**PLEASANT PRAIRIE PLAN COMMISSION MEETING
VILLAGE HALL AUDITORIUM
9915 39th AVENUE
PLEASANT PRAIRIE, WISCONSIN
6:00 P.M.
MARCH 23, 2015**

- A. **PUBLIC HEARING AND CONSIDERATION OF PLAN COMMISSION RESOLUTION #15-06 FOR THE FOLLOWING COMPREHENSIVE PLAN AMENDMENTS** for the request of Leah Berlin on behalf of Kwik Trip, Inc. related to the proposed development of a Kwik Trip to be located at the southwest corner of STH 50 and CTH H: 1) to amend the Village 2035 Land Use Plan Map 9.9 to remove the urban reserve land use designation from the property identified as Tax Parcel Number 91-4-122-081-0010 to ensure that both the Zoning Map and the Comprehensive Land Use Plan are consistent; and 2) to update Appendix 10-3 of the Village of Pleasant Prairie Wisconsin, 2035 Comprehensive Plan to reflect the above noted changes to the 2035 Land Use Plan Map 9.9.

- D. **PUBLIC HEARING AND CONSIDERATION OF A CONDITIONAL USE PERMIT INCLUDING SITE AND OPERATION PLANS AND DIGITAL SECURITY IMAGING SYSTEM AGREEMENT AND ACCESS EASEMENT** for the request of Leah Berlin on behalf of Kwik Trip, Inc. related to the proposed development of a Kwik Trip to be located at the southwest corner of STH 50 and CT

DRAWN BY JSK/RWI
 SCALE 1" = 30'
 JSD PROJ. NO. 14-6612A
 DATE 02-15-2015
 SHEET 4 OF 22 SP3.0

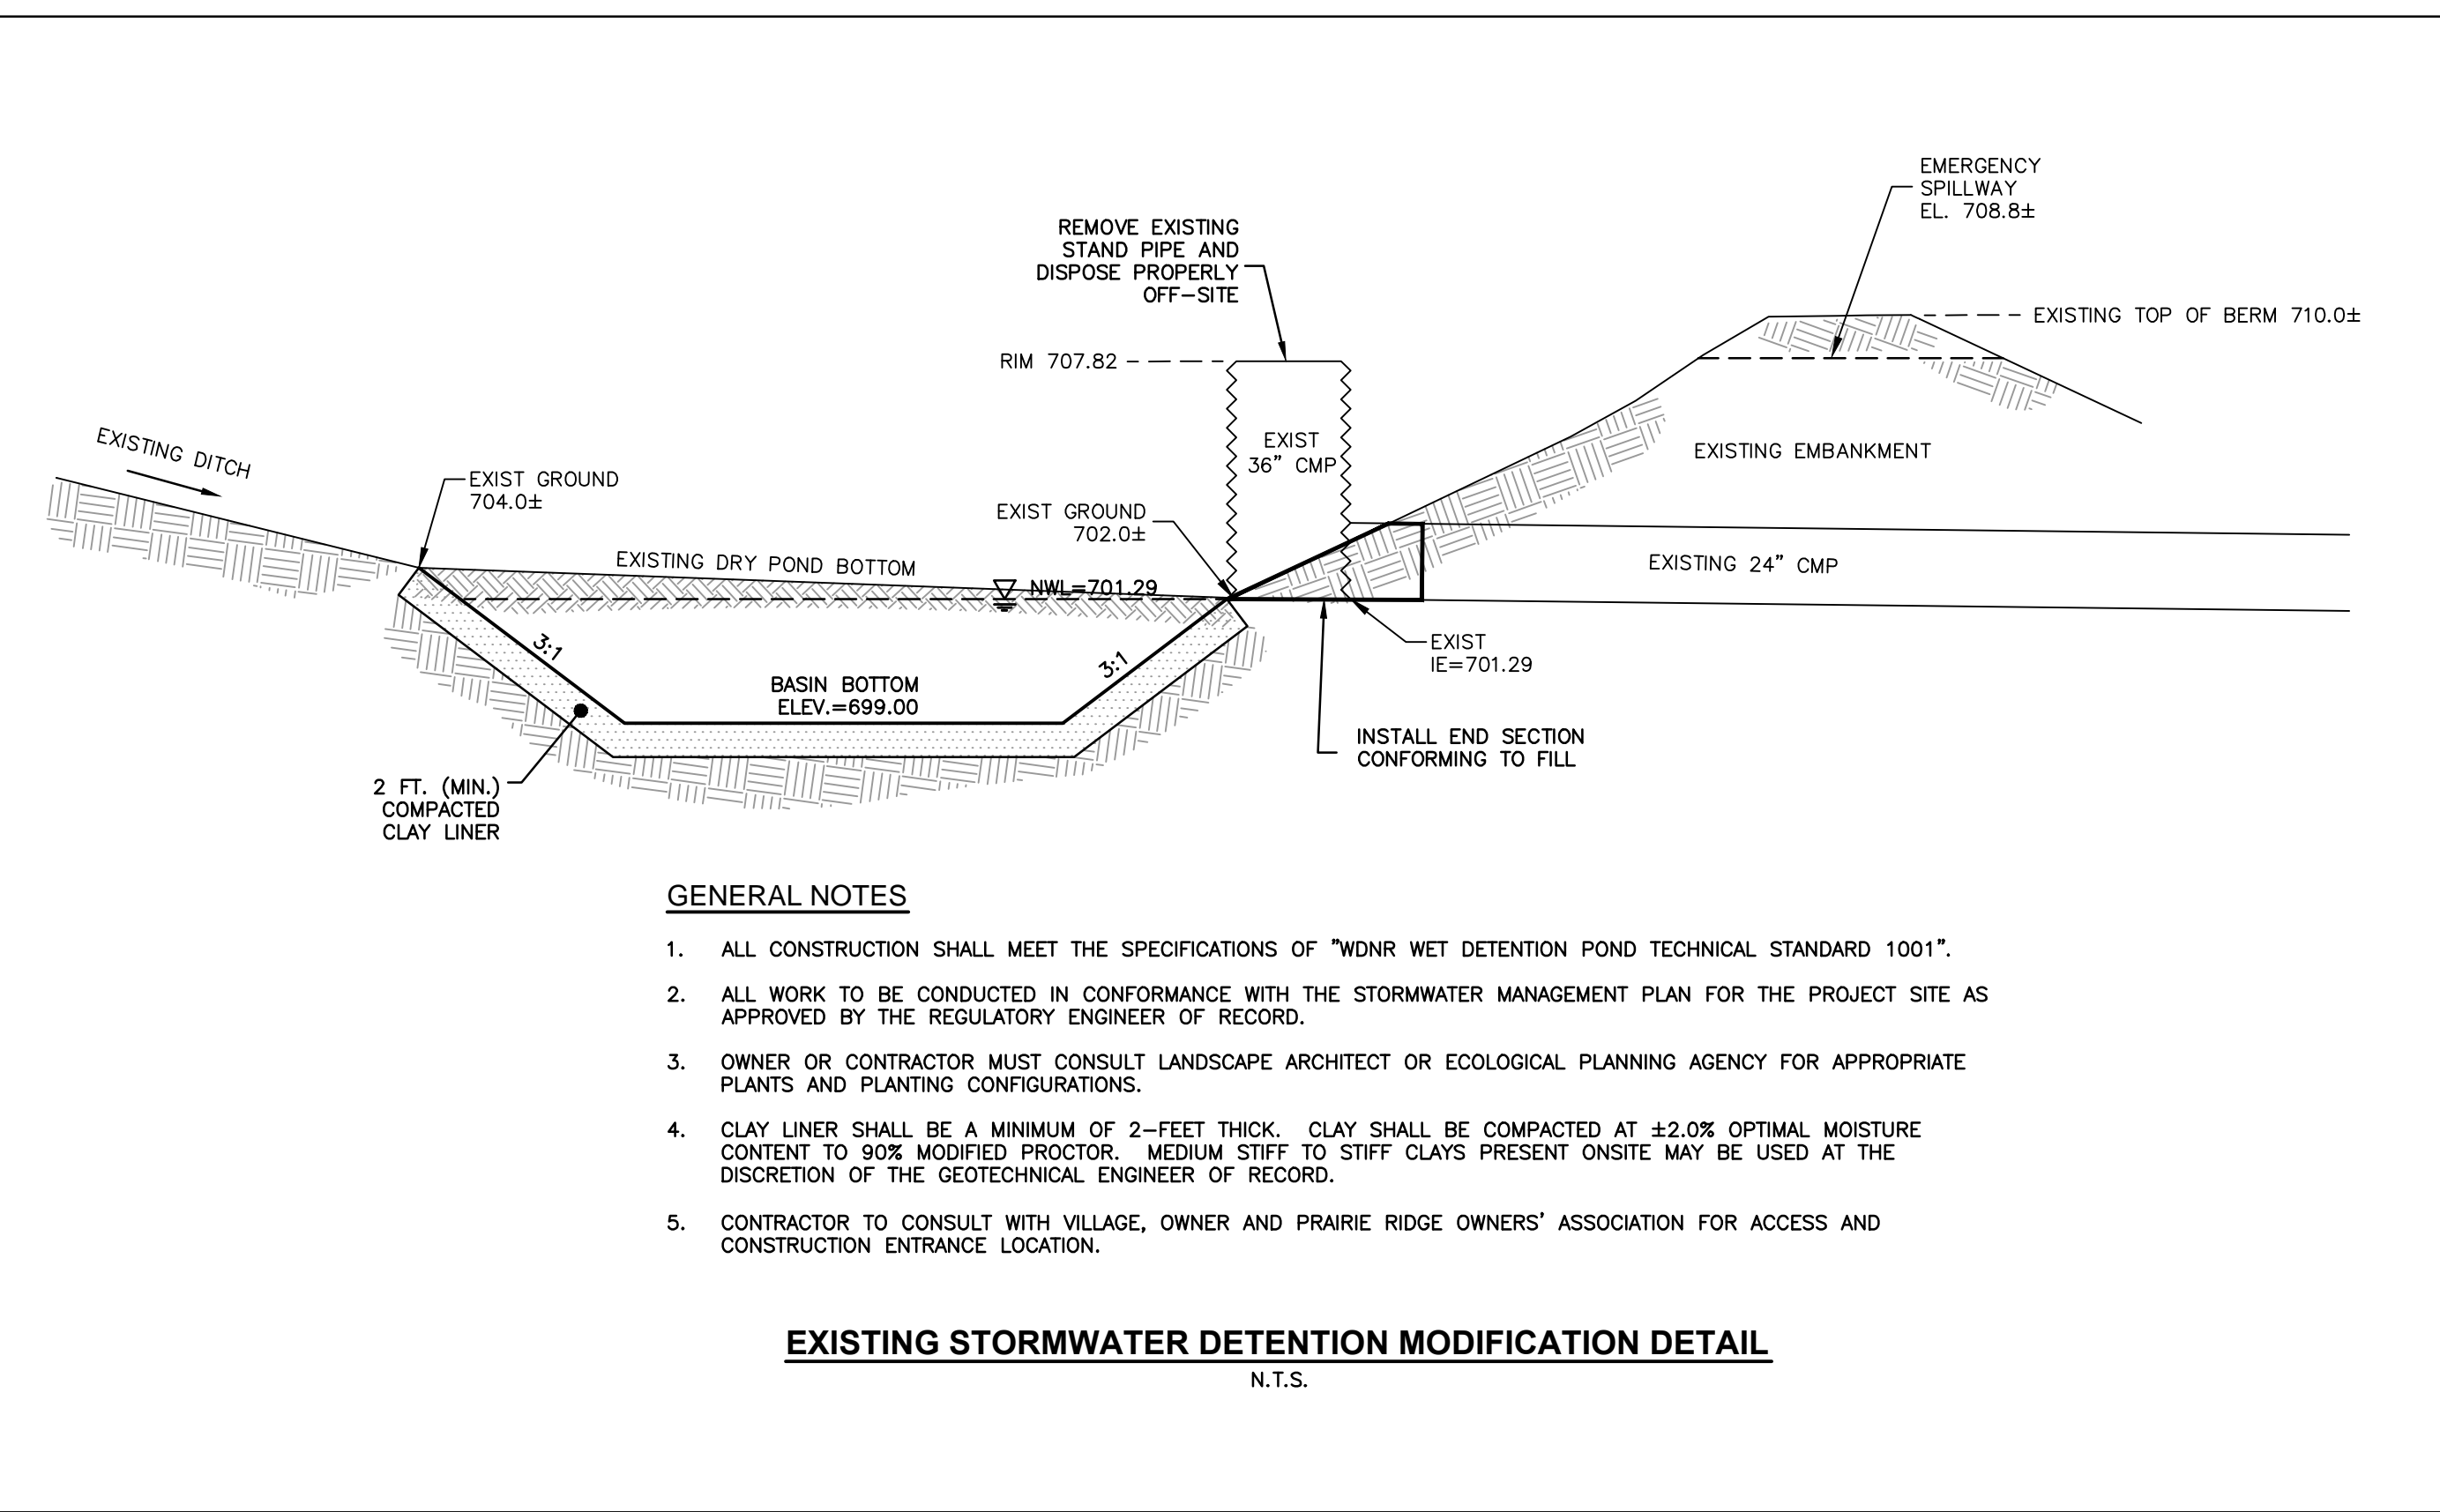
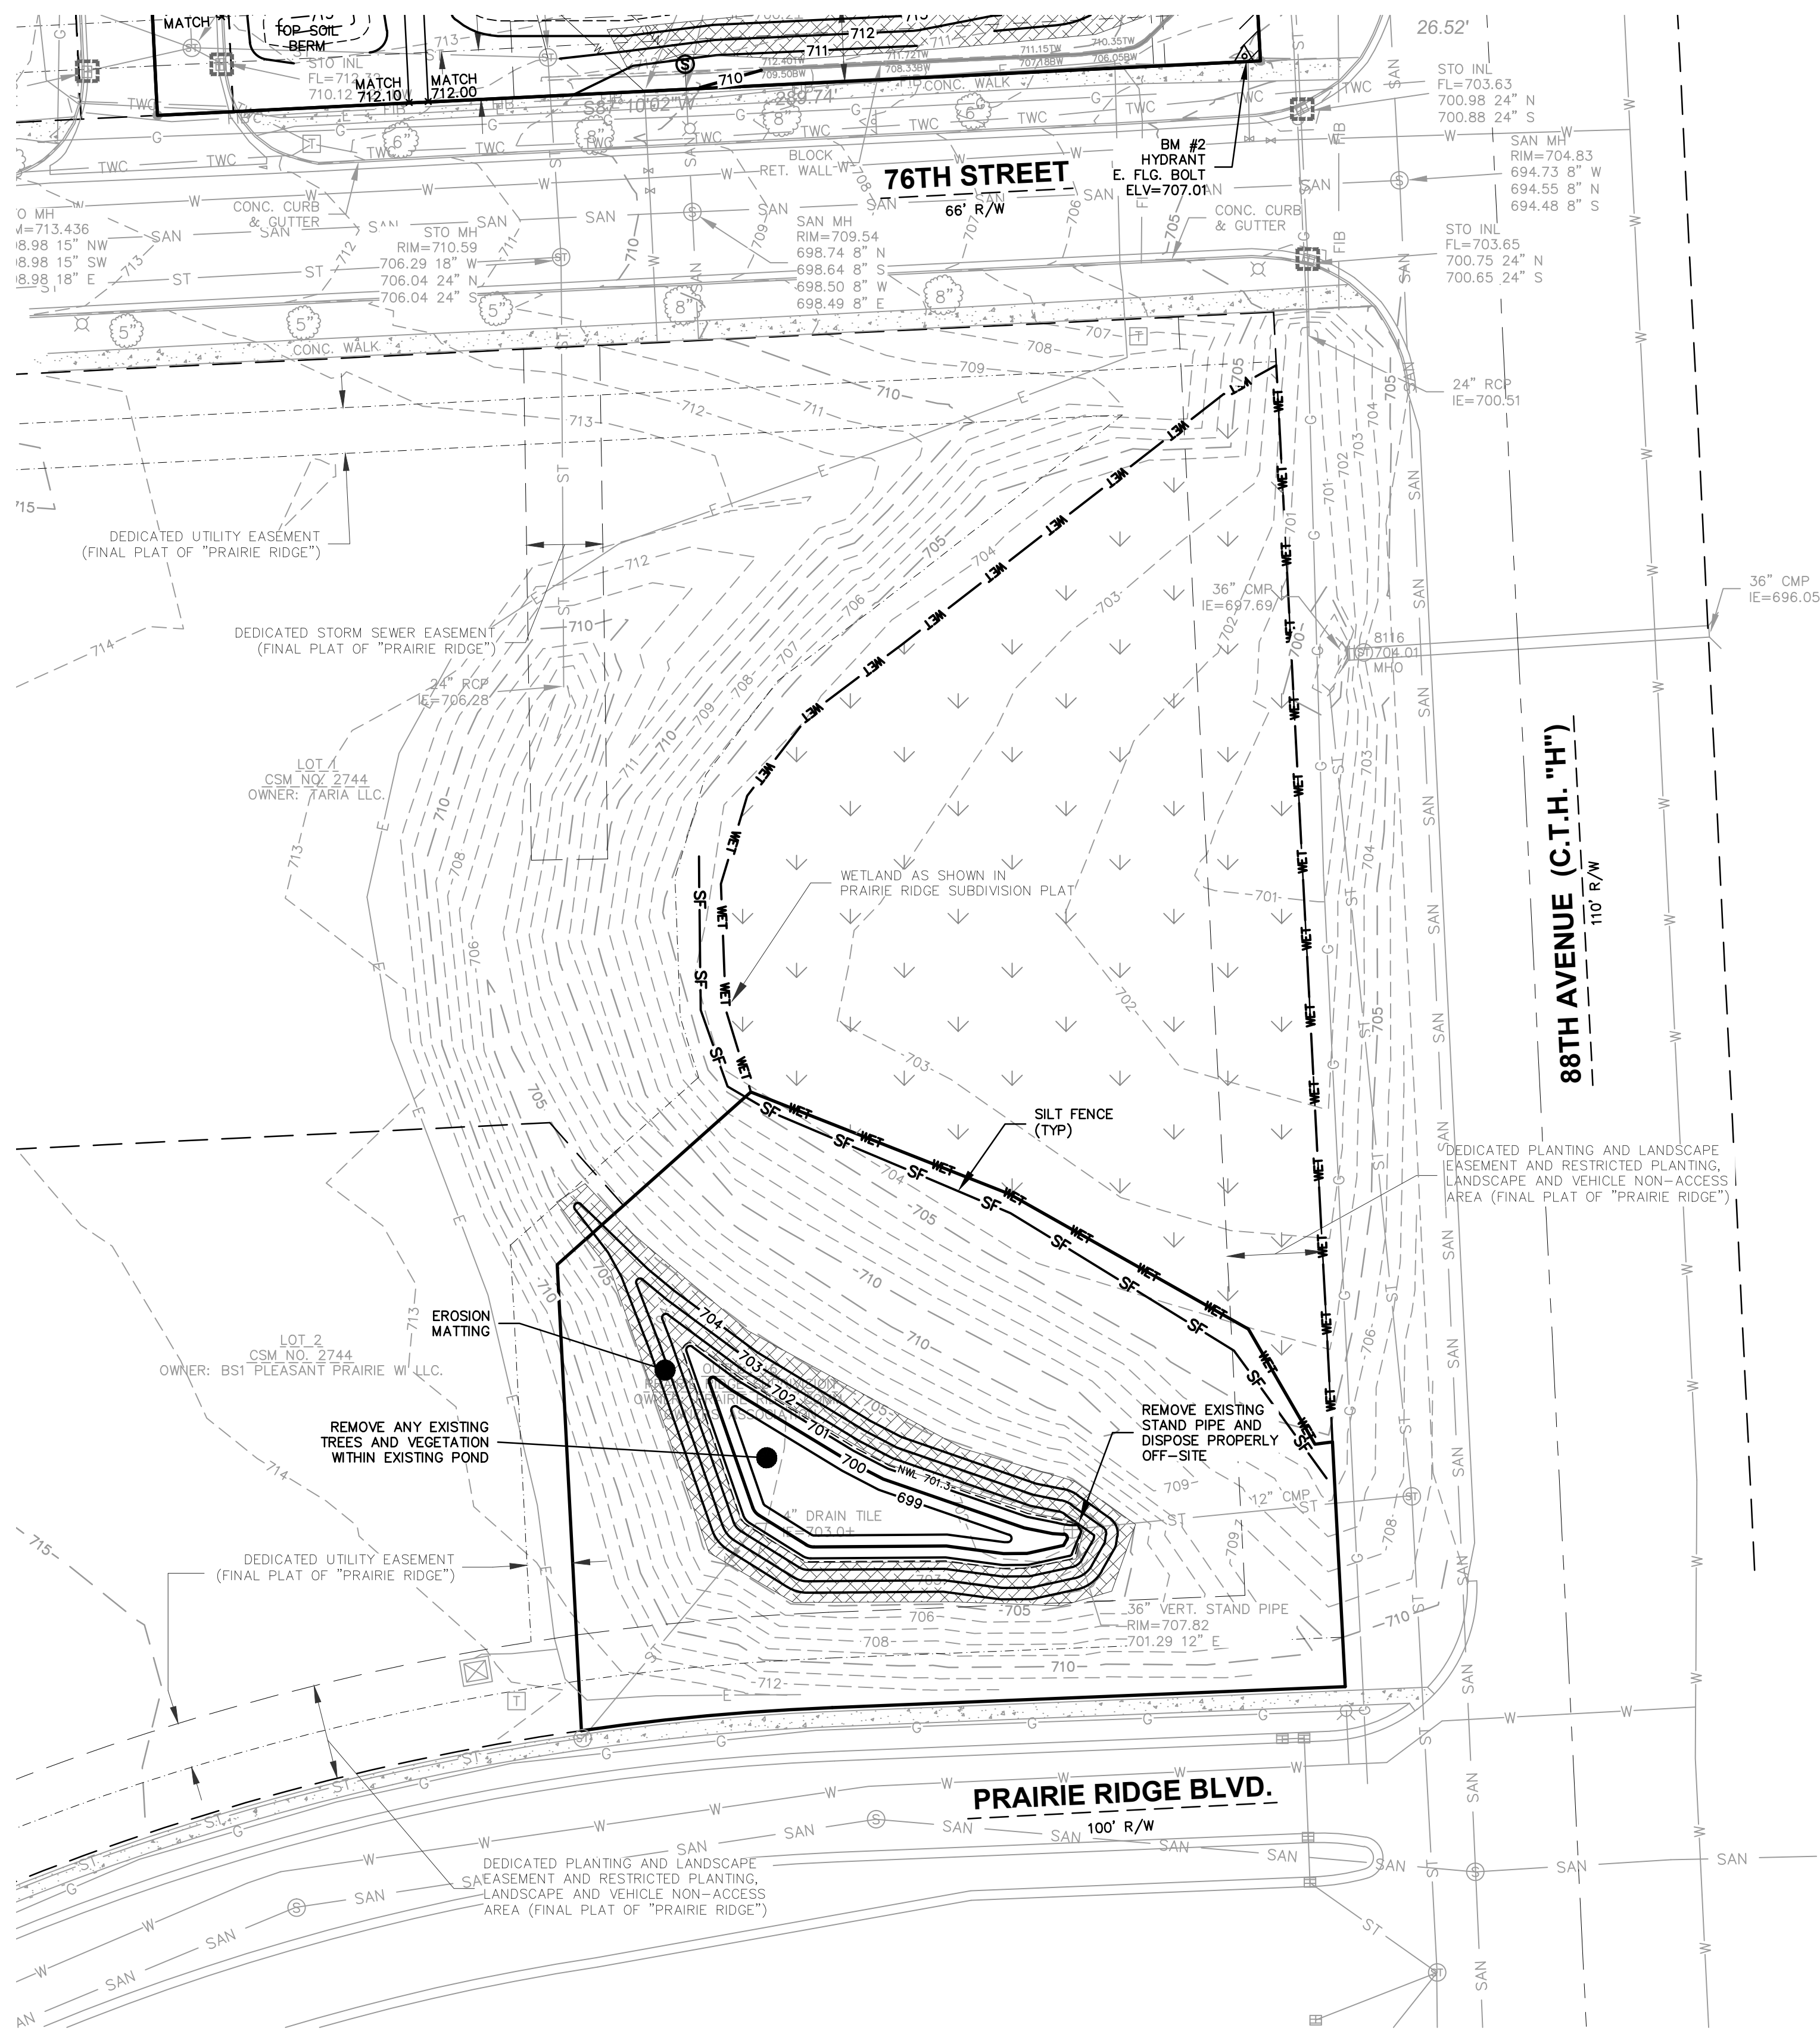
- (d.) Install a bulkhead at the manhole where the 24” storm sewer will be removed adjacent to 76th Street.
 - v. On the *Grading and Erosion Control Plan (Sheet SP3.0)* the following changes are required:

- (c.) Annotate typical slopes.
 - (d.) What is the horizontal line located 20' north of BM #2?
- vi. On the *Grading and Erosion Control Plan – Offsite Improvements (Sheet SP3.1)* the following changes are required:

- j. Modify Plan Sheet 3:
- i. All overhead electrical lines shall be buried.
 - ii. Note "No direct access from property to 76th Street per the Village of Pleasant Prairie."
